SUNDRY NOTICES AND REPORTS ON WELLS
Do not use this form for proposals to drill or to re-enter an abandoned well. Use form 3160-3 (APD) for such proposals.

EOG PROPOSES TO PLUG AND ABANDON THIS WELL USING THE ATTACHED PROCEDURE.

**** BLM REVISED ** BLM REVISED ** BLM REVISED ** BLM REVISED ** BLM REVISED ****

Adeline ALN Federal #16 – P&A

Proposed Wellbore Diagram:

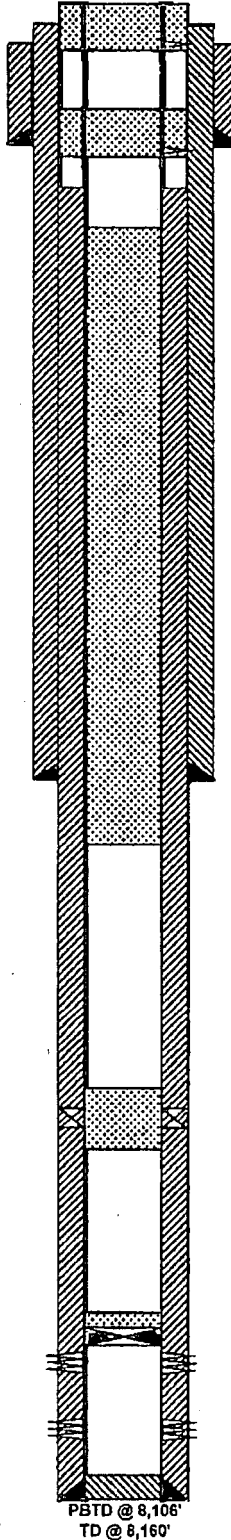
Below ground level dry hole marker Required

* APD Shows Secretary's Potash only. Spot ent from 4260 ~ 3935. WOC Tag (T/Delaware, shoe & B/salt).
Perf @ 995 attempt to sqz ent to 895. WOC Tag, (T/salt).
